No. 2018/M(N)/172/1(E-3323008)

Sub: Wornout of anticreep in CBCs

**Sub: Worn out of anticreep in CBC s**

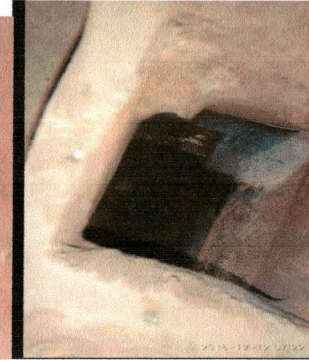
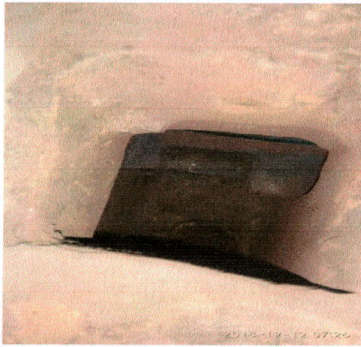
On scrutiny, anticreep of CBC body found worn out, breakage and also found missing in some wagons. . It can seen in the photographs given below-

- 1) Service limit for wear on the anticreep lug has to be specified during ROH and POH attention.
- 2) Wagon workshops may be strictly advised to check the availability of proper anticreep lug in all the CBC.
